PRODUCT CHANGE NOTIFICATION NO: PC-1808025

PCN DATE: Sep 14th, 2018

1X1 ICM Product

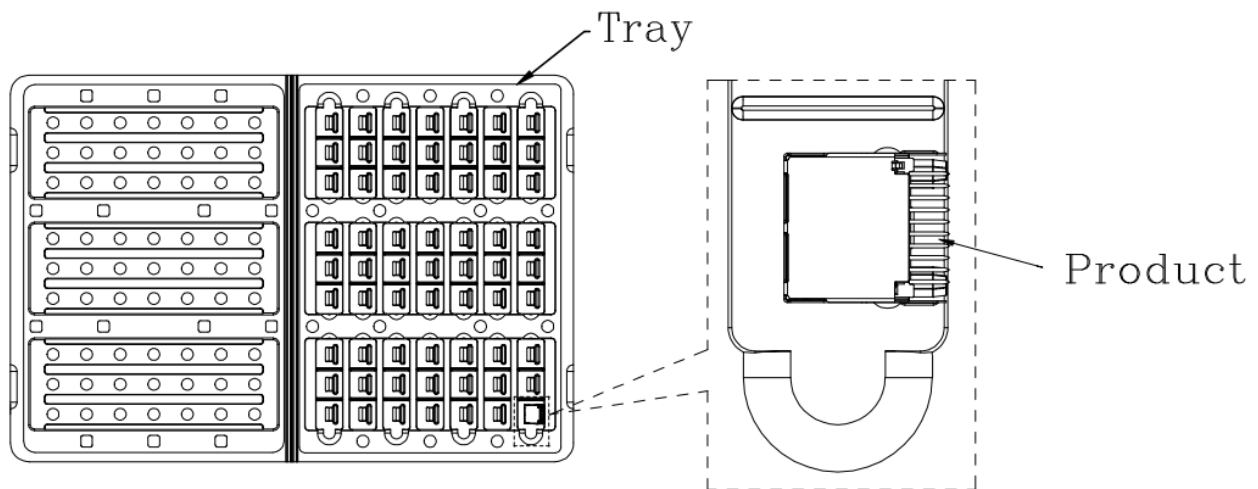
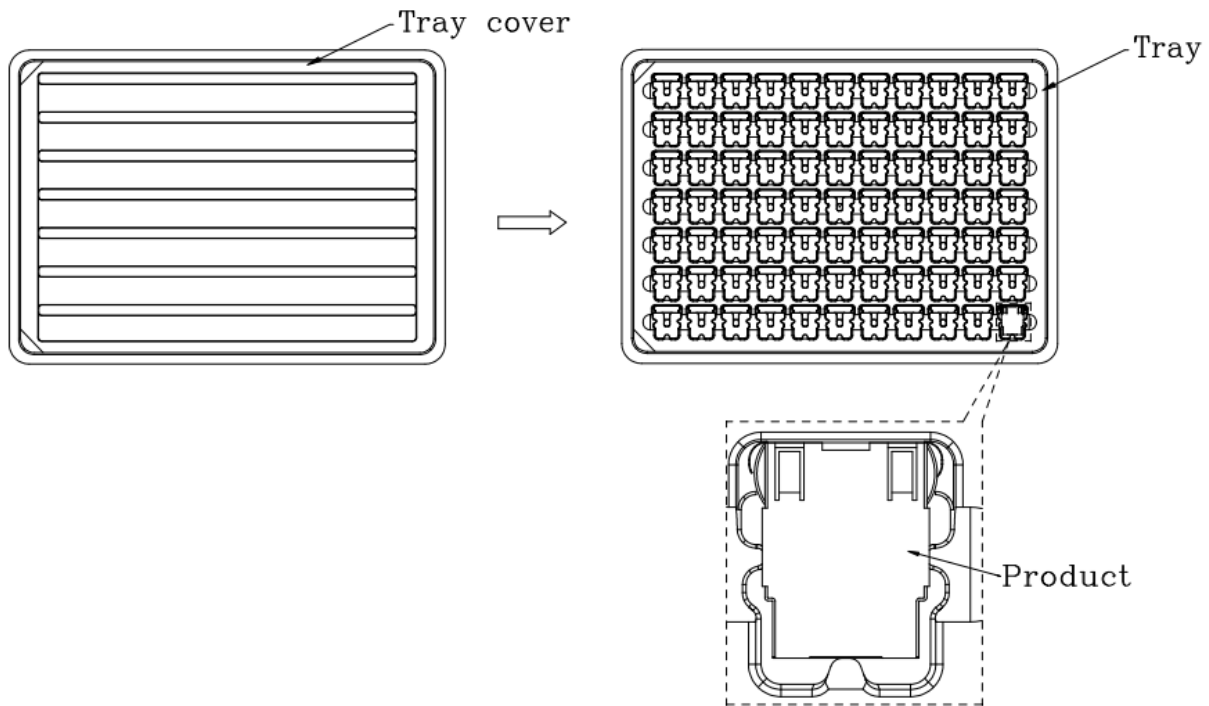
We received customer complaint about 1X1 ICM product tray package, it is too loose to pass drop testing and has potential risk. This tray was designed many years ago, no drop test requirement at that moment, so we want to use new tray design for package improvement.

Redesign package, SPQ/PPQ & MOQ are changed.

1. Part placement is like below picture

2. Pack 63 pcs / tray and 315 pcs / full carton
3. MOQ was 315pcs

1. Part placement is like below picture

2. Pack 77 pcs / tray and 385 pcs / full carton

3. MOQ is 385pcs
